# NOTICE OF DECISION

**MAJOR HISTORIC DESIGN REVIEW CASE NO. HIS17-38**

**SUMMARY:** A proposal to add new signage, replace the storefront and construct a new addition on the rear of the Starkey/McCully Building (1867).

# THE STARKEY-McCULLEY BUILDING 1867 REMODEL & APARTMENT ADDITION

1 EAST EXTERIOR ELEVATION  
A3.1 SCALE: 1/8"=1'-0"

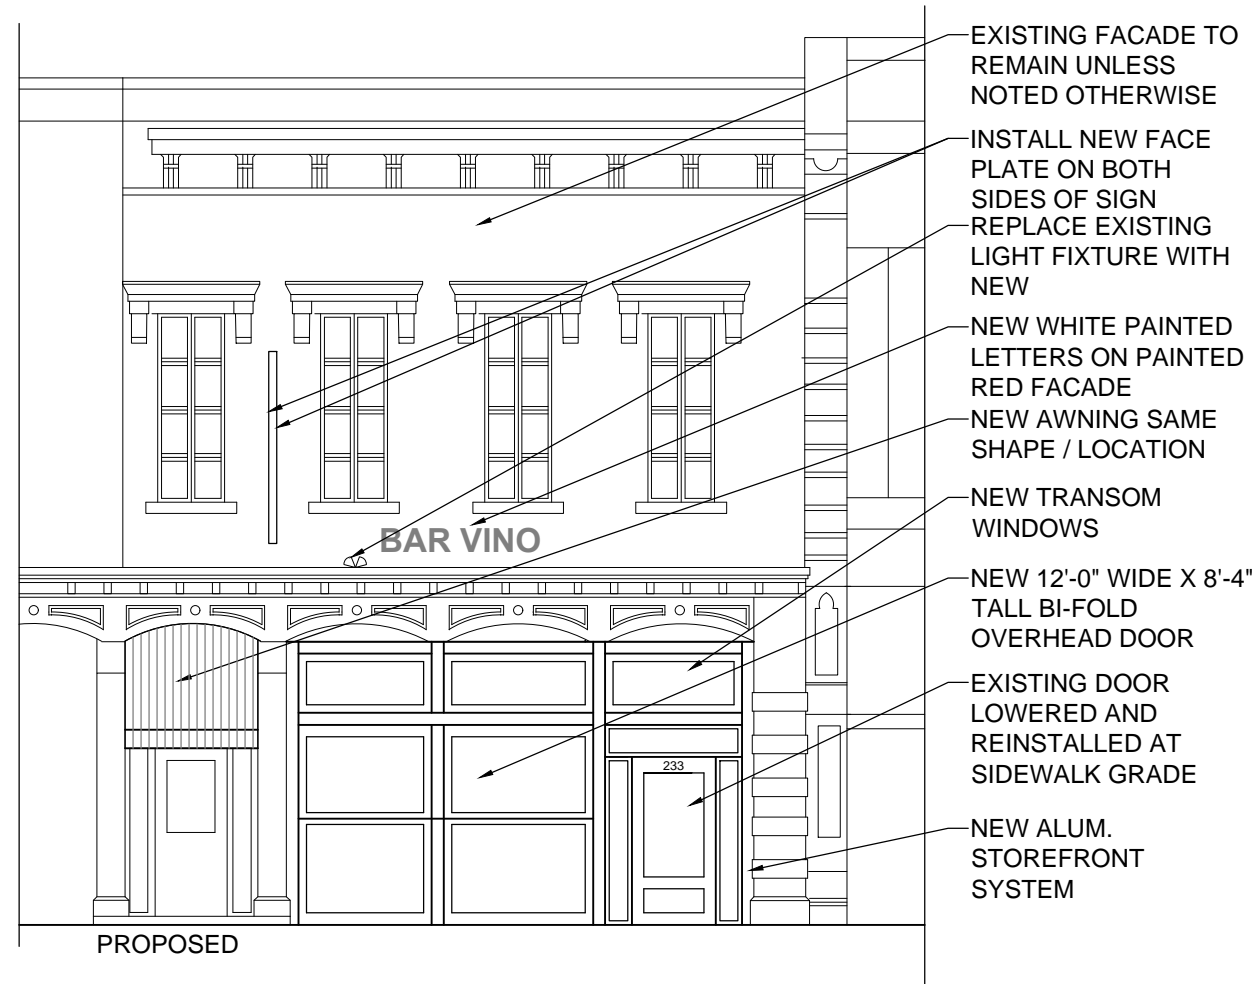
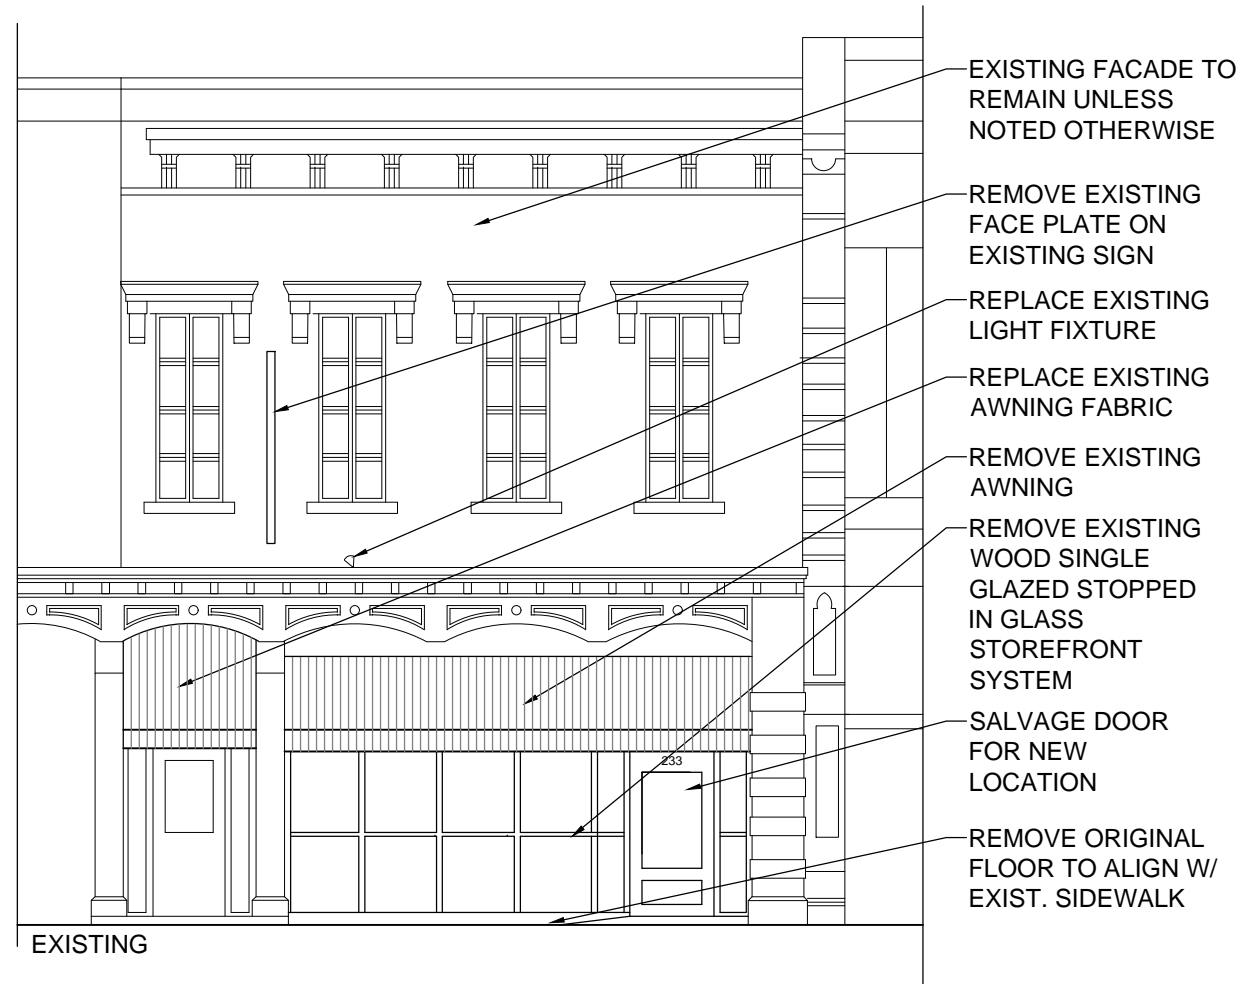
**Finding:** "Sign B" is proposed to be located above the transom, in a location typically used for painted signage during the period of significance. The HLC finds that the proposal meets this criterion.

**Finding:** "Sign B" would be painted on the façade, and therefore flush to the façade. The HLC finds that the proposal meets this criterion.

**Finding:** "Sign B" would be located on the brick face of the front façade, outside of the transom area. The HLC finds that the proposal meets this criterion.

**Finding:** "Sign B" would be located on a flat portion of the brick face of the front façade, and would not cover windows or any significant architectural features. The HLC finds that the proposal meets this criterion.

**Finding:** “Sign B” would be centered above the storefront on the front façade of the subject portion of the resource. The main entrance to the restaurant is located on the northern end of this storefront, in close proximity to the proposed sign location. The HLC finds that the proposal meets this criterion.

**Finding:** “Sign B” would apply white lettering to the existing dark red painted brick background. The HLC finds that the proposal meets this criterion.

3 WEST ELEVATION  
A3.1 SCALE: 1/8" - 1'-0"

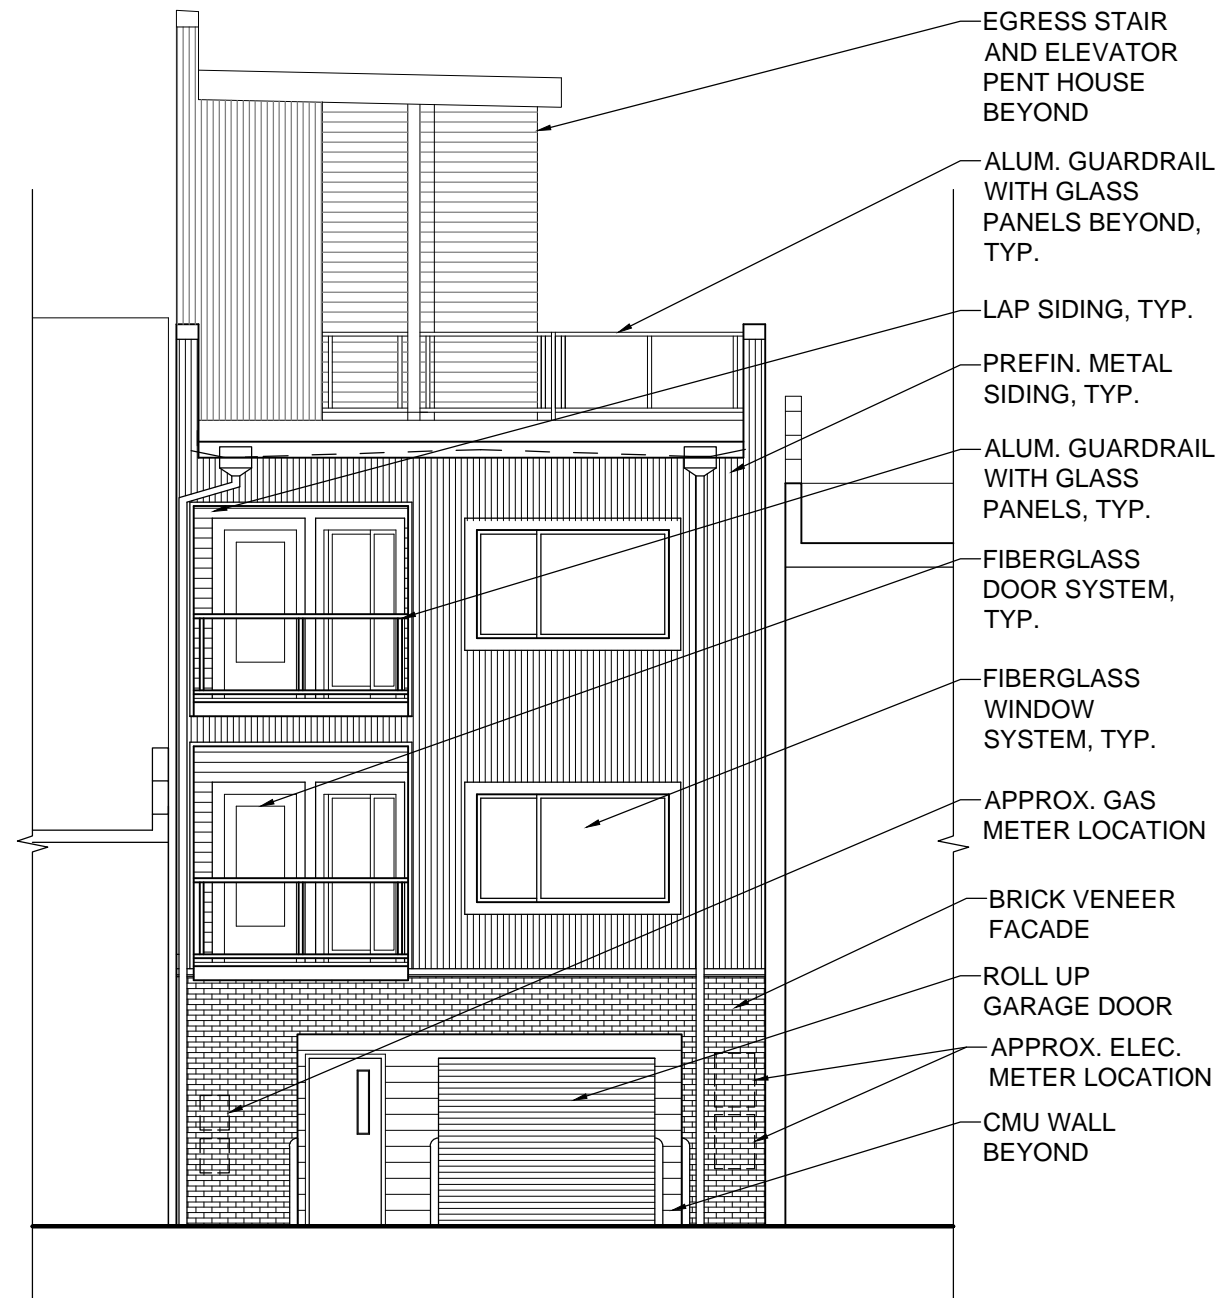
**CONDITION 1** – All new facades facing a public right of way (west façade) shall be clad in a brick veneer at the first story (approximately 11’-0” tall).

## STARKEY-McCULLEY PAINTED SIGNS EXAMPLES

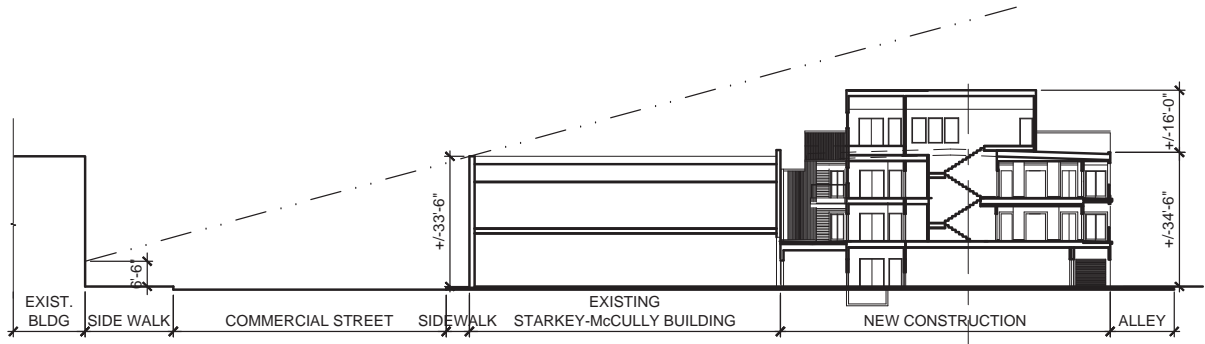
**Finding:** The applicant has provided photographic evidence (Attachment C1) showing that the adjacent southern portion of the Starkey-McCully Building (223 Commercial Street NE) has historically included painted signs at this specific level of the façade, just below the second story windows. The proposed location of “Sign B” at this level of the façade follows the historic precedence of painted signage on this location, identifying businesses occupying the storefronts below. The sign would be painted onto a brick surface that has been painted over many times. The HLC finds that the proposal meets this criterion.
